- SUBJECT: 1. Environmental Determination
2. Tentative Map (P88-424)

LOCATION: North Side of Lemon Hill Avenue, 2,000 Feet East of Stockton
 Boulevard

RESUBMISSION
TENTATIVE MAP
LEMON HILL ESTATES
 CITY OF SACRAMENTO
 SEPTEMBER 1988

SUBDIVISION REVIEW COMMITTEE RECOMMENDATION: On November 16, 1988, by a vote of six ayes and three absent, the Subdivision Review Committee voted to recommend denial of the tentative map. The applicant redrew the map and submitted to staff, December 1, 1988, to reflect conditions of approval stated at the Subdivision Review Committee meeting if the Commission or Council approved the project. In addition, the revised map was reviewed by Fire Department, Traffic Engineering and City Engineering. These departments support the revised map.

RESUBMISSION
TENTATIVE MAP
LEMON HILL ESTATES
CITY OF SACRAMENTO
SEPTEMBER 1988

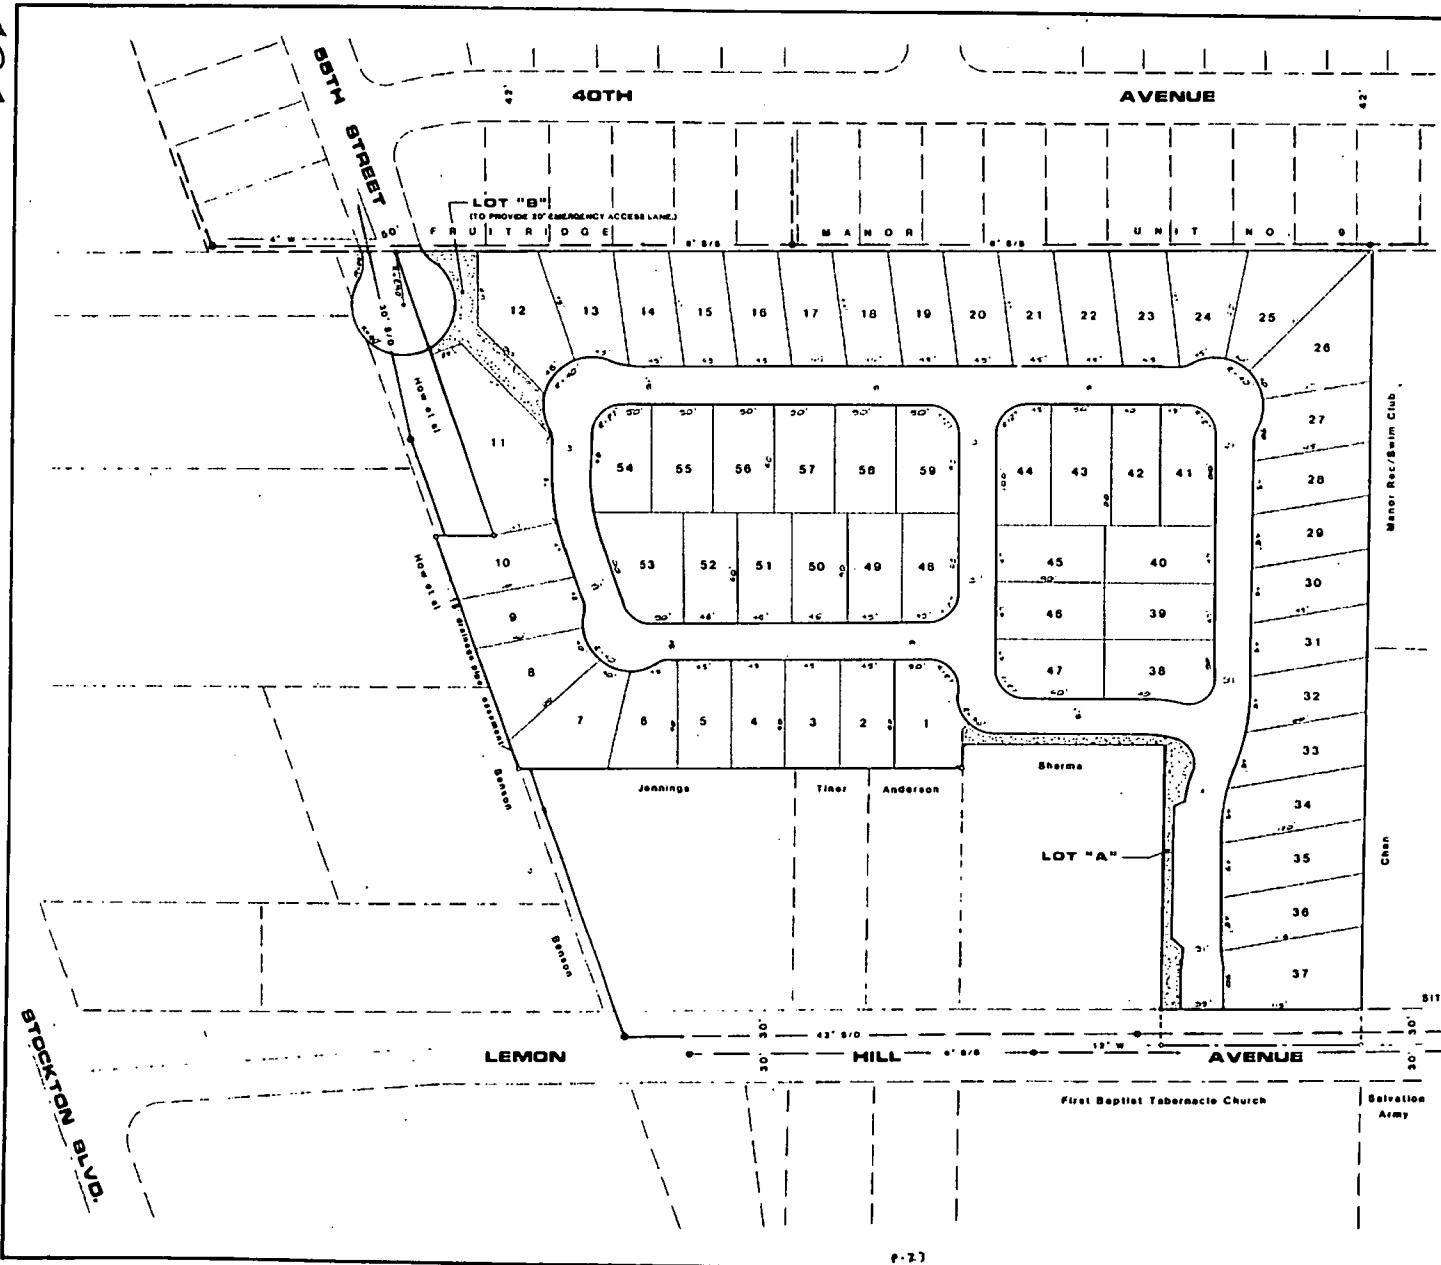
Staff has reviewed the proposed project in light of the 1983 conditions of approval. The following revisions should be incorporated into the revised map.

1. A cul-de-sac bulb is shown extended from 55th Street where a private road easement was shown. In providing the bulb, concern expressed by the City Engineer, Traffic Engineer and Fire Marshall's office have been addressed.

2. It is necessary to obtain off-site right-of-way for the cul-de-sac. The City Engineer has indicated that the city will use its condemnation powers to obtain off-site right-of-way at the owner's expense if an agreement cannot be reached with the adjoining property owner.

5. The original tentative map showed the southern 25 feet of Lot 1, adjacent to Lemon Hill Avenue as a separate landscape lot. The current proposal shows the 25 foot area as part of Lot 1. Staff

recommends a 20 foot landscape setback adjacent to Lemon Hill Avenue. Intensive landscaping is recommended with two to three foot high landscape berm adjacent to Lemon Hill Avenue.

- 6. The commonly owned landscaped area should be designated Lot A and Lot B and the private street designated Lot C on the final map. These areas are to be owned and improved by a homeowners' association. Conditions, covenants and restrictions of the association should be subject to review by the City Attorney prior to final map recordation.

- 11. In order to buffer the proposed residences from the noise of adjacent commercial uses, staff requests a solid six-foot high, decorative masonry wall be erected along the west and south property lines abutting commercial uses or zones.

8. Redesign to include standard streets widths (31 ft. back of curb to back of curb) standard cul-de-sacs and secondary access;
9. Driveway off of Lemon Hill Avenue is to be a maximum of 35 feet and constructed to city standards;

10. No access shall be allowed from the cul-de-sac into the commercial development to the west;
11. Construct a 40 ft. radius cul-de-sac at the end of 55th Street; Will require off-site dedication;

12. Provide emergency access into development through the cul-de-sac;
13. Provide on-site fire hydrants at locations approved by the City Fire Marshall's Office;

14. Provide on-site water main loop (from Lemon Hill to 40th Avenue).
15. All driveways shall be constructed with minimum 35 ft. inside turning radius;
16. Dedicate the north five feet of the entire subdivision as a public utility easement for underground and overhead electrical facilities and appurtenances;

FLOOR PLAN ELEVATIONS

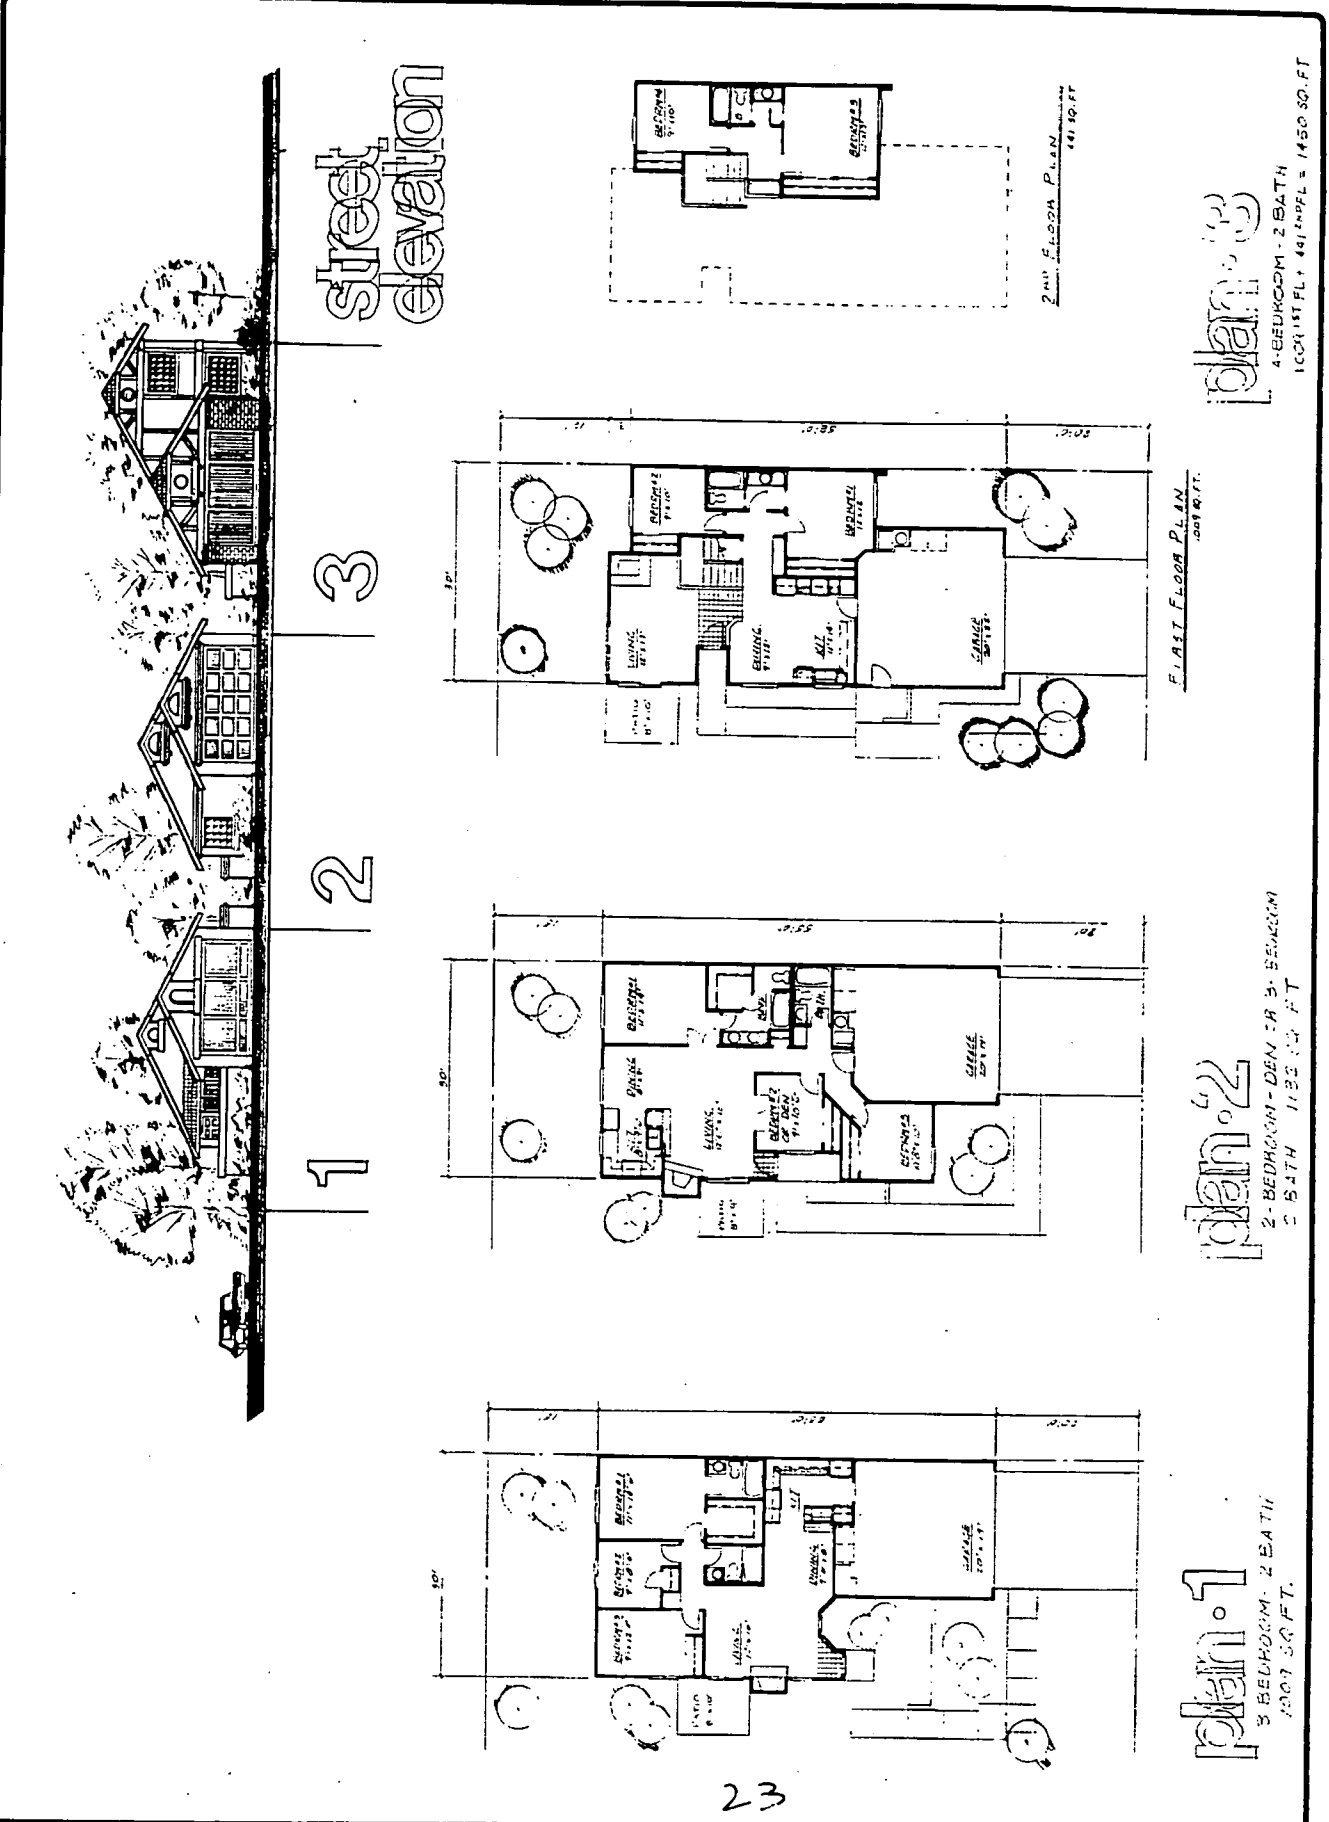
4. Only three exterior elevations are provided. Ordinarily staff would recommend additional elevations. However, the applicant is attempting to avoid a cluttered appearance by the use of many elevations. A varied and interesting streetscape will be achieved by emphasizing heavily landscaped front yards, various courtyard treatments and carefully selected colors, textures and materials.

EXHIBIT
"A" 16

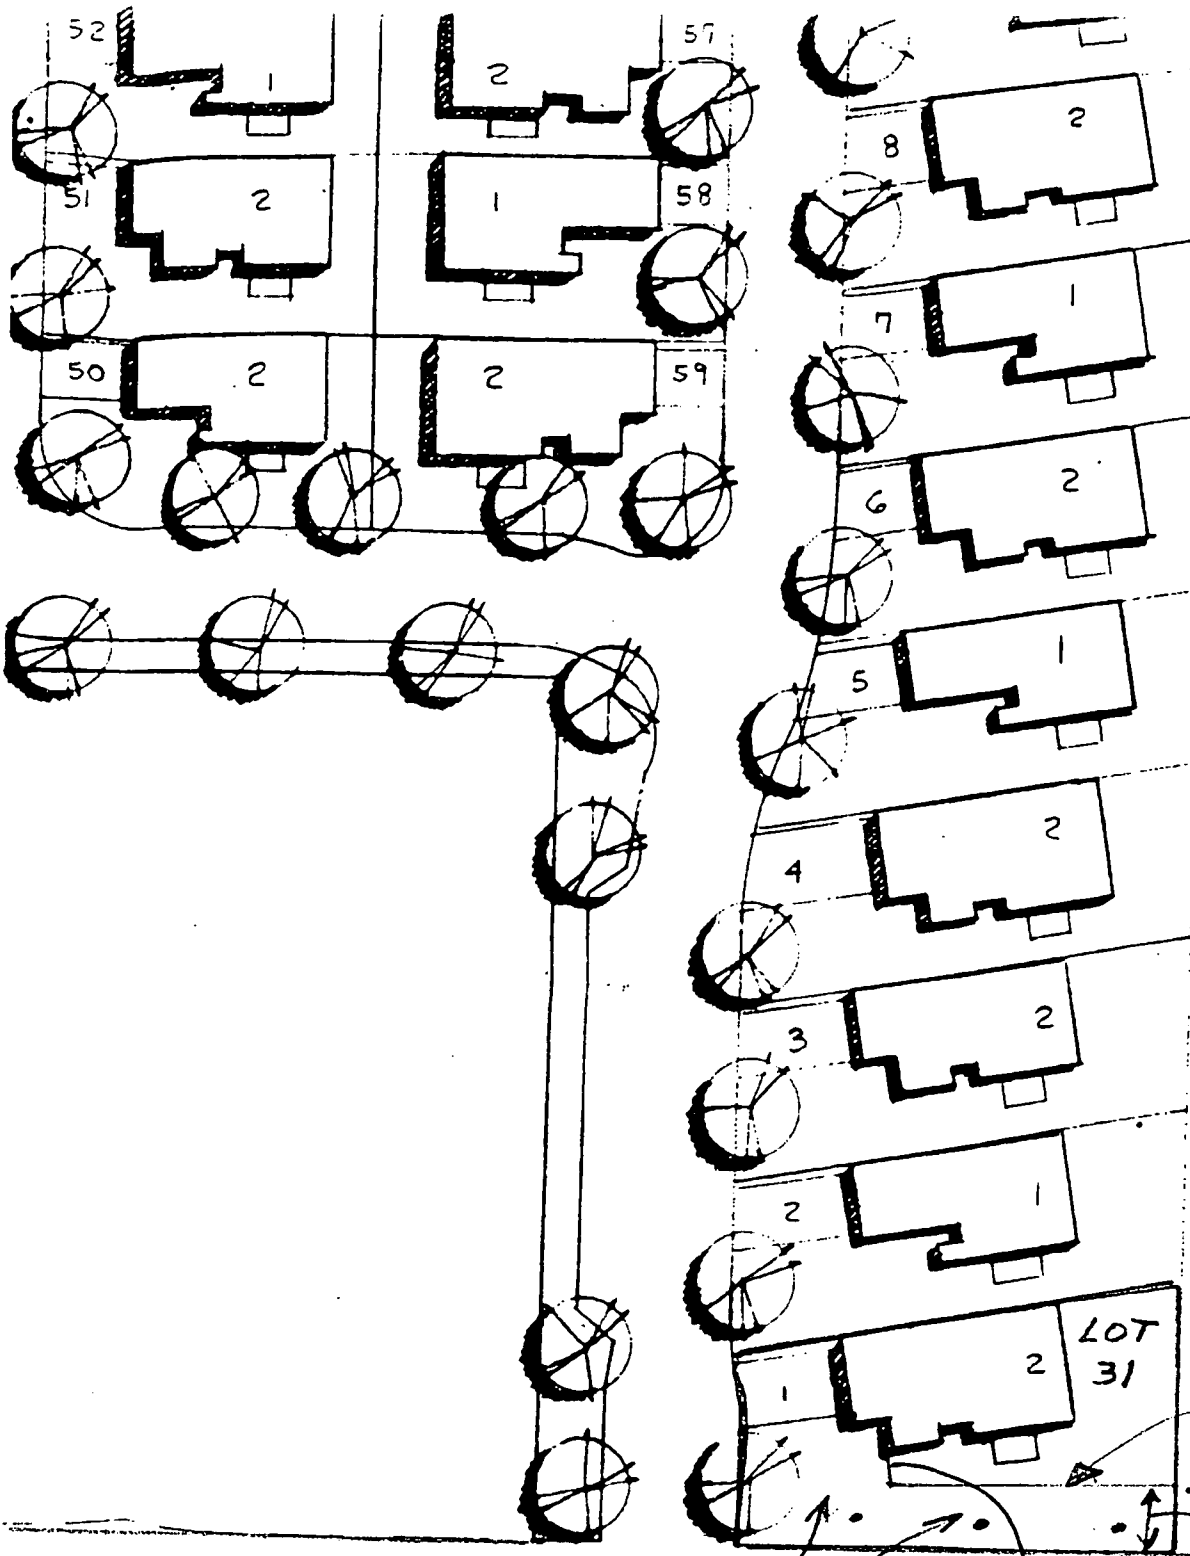
- 3. Detailed landscaping and irrigation plans were not provided. Staff recommends review and approval of landscape plans by the Planning Director prior to issuance of building permits.
- 4. Lot No. 37 that fronts on Lemon Hill Avenue should be designed to provide a minimum of 20 feet of landscape setback along Lemon Hill Avenue. In addition, a six foot high decorative masonry wall should be installed to provide a sound barrier and privacy wall. The distance between the wall and the dwelling should be a minimum of 10 feet. See Exhibit A for details.
- 5. If possible, a variable front building setback should be provided in order to create interest along the streetscape.

- 6. The project shall be developed per the submitted site plan, elevation, footprints, tile roofs, chimneys and building material;
- 7. The applicant shall design lot 37 with a 20 foot landscape setback with a two to three foot undulating berm consisting of lawn and trees along the Lemon Hill frontage. A six foot high, decorative masonry wall shall also be installed as indicated in Exhibit A.

EXHIBIT A-1

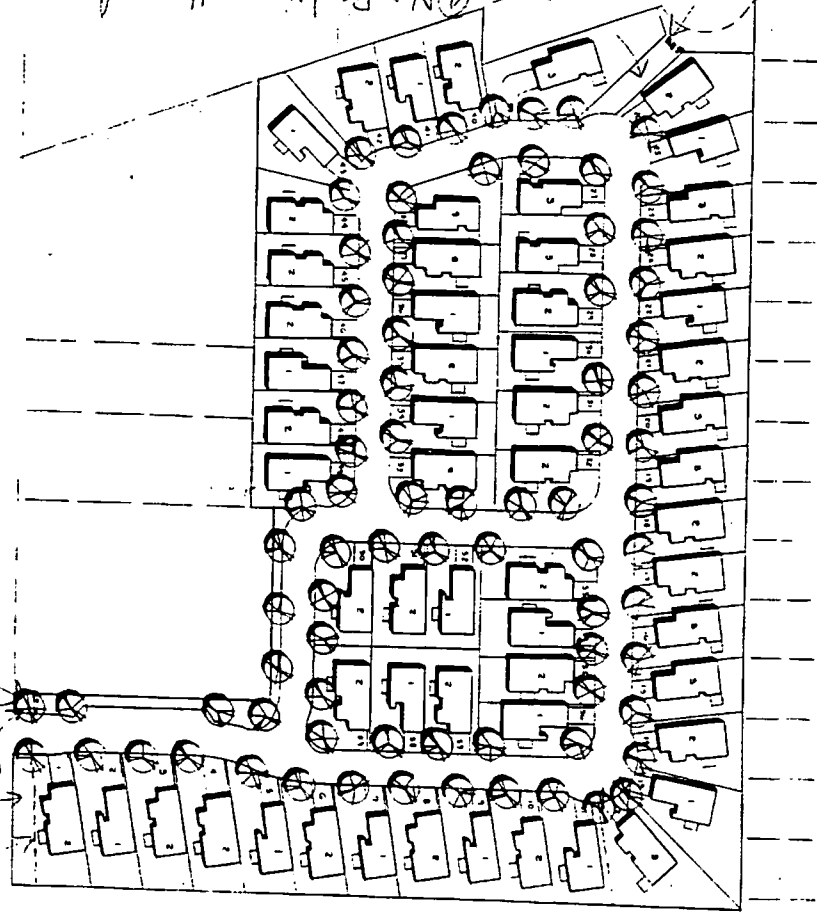
- 1. The western portion of the cul-de-sac bulb (55th Street) should have barricades to prevent access to the rear of the commercial properties located to the west. Staff recommends the applicant revise the site plan to show barriers along the west side of the cul-de-sac bulb.
- 2. Staff recommends all yards be fenced with six ft. high solid board fencing.
